E/ECE/324 }
E/ECE/TRANS/505 } Add.4/Rev.3/Amend.1

Addendum 4: Regulation No. 5

Revision 3 - Amendment 1

UNIFORM PROVISIONS FOR THE APPROVAL OF MOTOR VEHICLE "SEALED BEAM" HEADLAMPS (SB) EMITTING A EUROPEAN ASYMMETRICAL PASSING BEAM OR A DRIVING BEAM OR BOTH

Figure 1

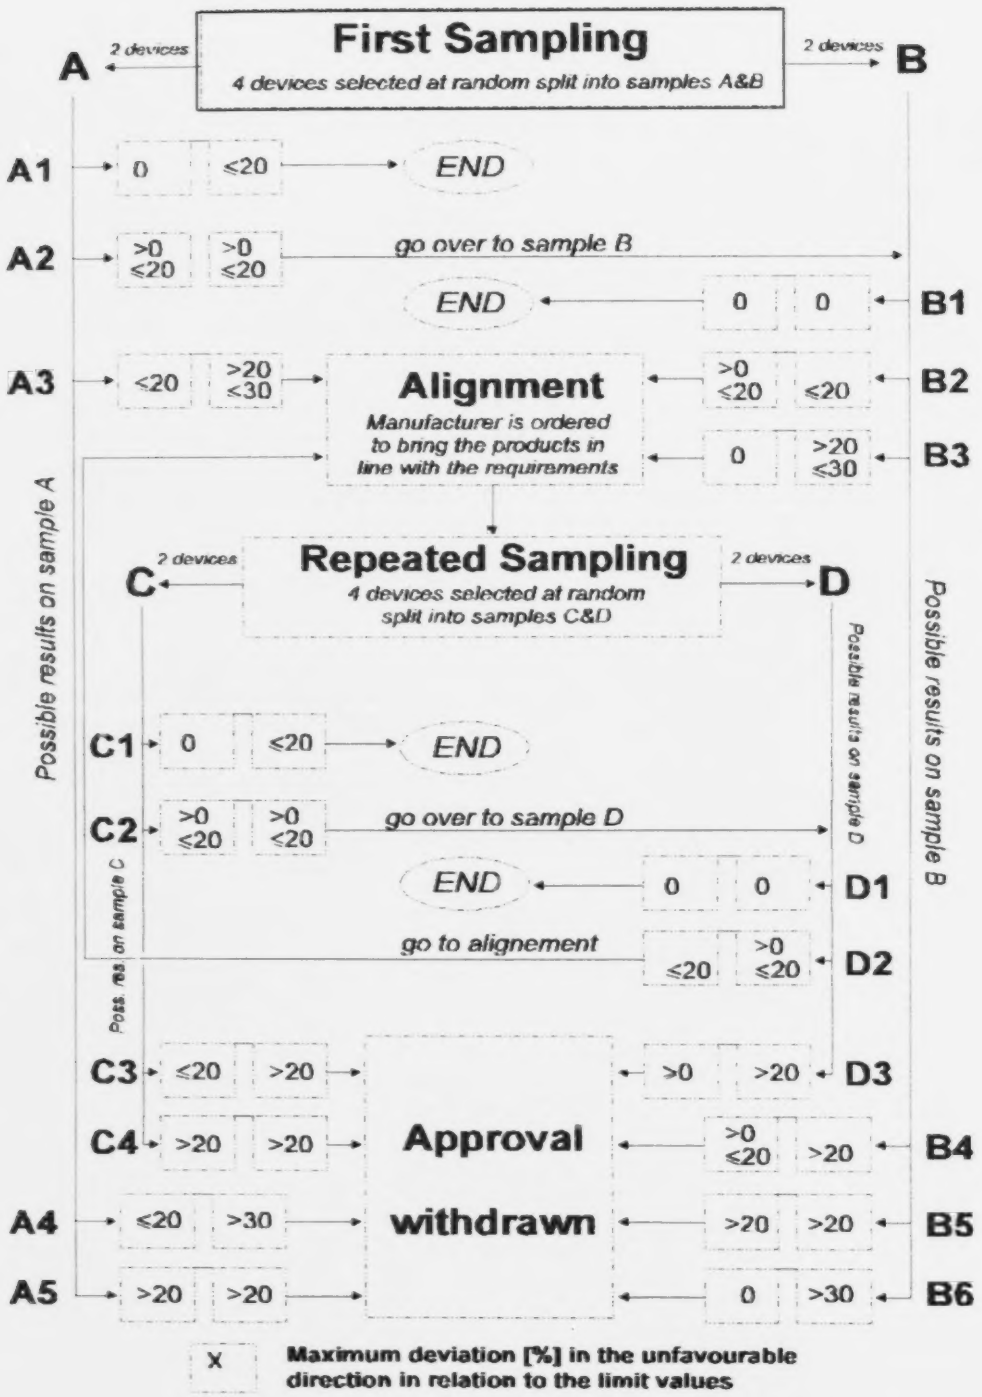
Add a new Annex 7, to read:

In the first sampling four headlamps are selected at random. The first sample of two is marked A, the second sample of two is marked B.

2.1.1. Following the sampling procedure shown in Figure 1 of this annex the conformity of mass-produced headlamps shall not be contested if the deviation of the measured values of the headlamps in the unfavourable directions are:

2.2.1. Following the sampling procedure shown in Figure 1 of this annex the conformity of mass-produced headlamps shall be contested and the manufacturer requested to make his production meet the requirements (alignment) if the deviations of the measured values of the headlamps are:

Conformity shall be contested and paragraph 10 applied if, following the sampling procedure in Figure 1 of this annex, the deviations of the measured values of the headlamps are:

In the cases of A3, B2, B3 a repeated sampling, third sample C of two headlamps and fourth sample D of two headlamps, selected from stock manufactured after alignment, is necessary within two months time after the notification.
